From: Mike Lasch - U.S. Aftermarket

Revised July 21, 2020

S-2000 FRU 2400 Fan Mounting Bracket Kits Bulleting - Notice of Product Improvement for Serviceability

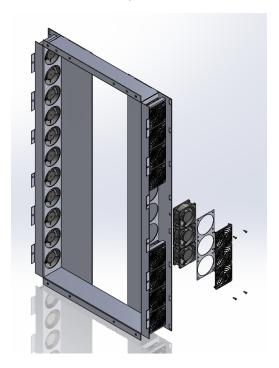
As a continuous improvement effort for serviceability, Unico has revised the fan mounting on air cooled 2400 series drives which utilize fan part number 938021. The sheet metal has been revised to facilitate replacement of the fan without disassembling the front of the inverter. The revised sheet metal and associated parts were introduced in May 2020 production.

See below for an exploded view of the new fan mounting arrangement.
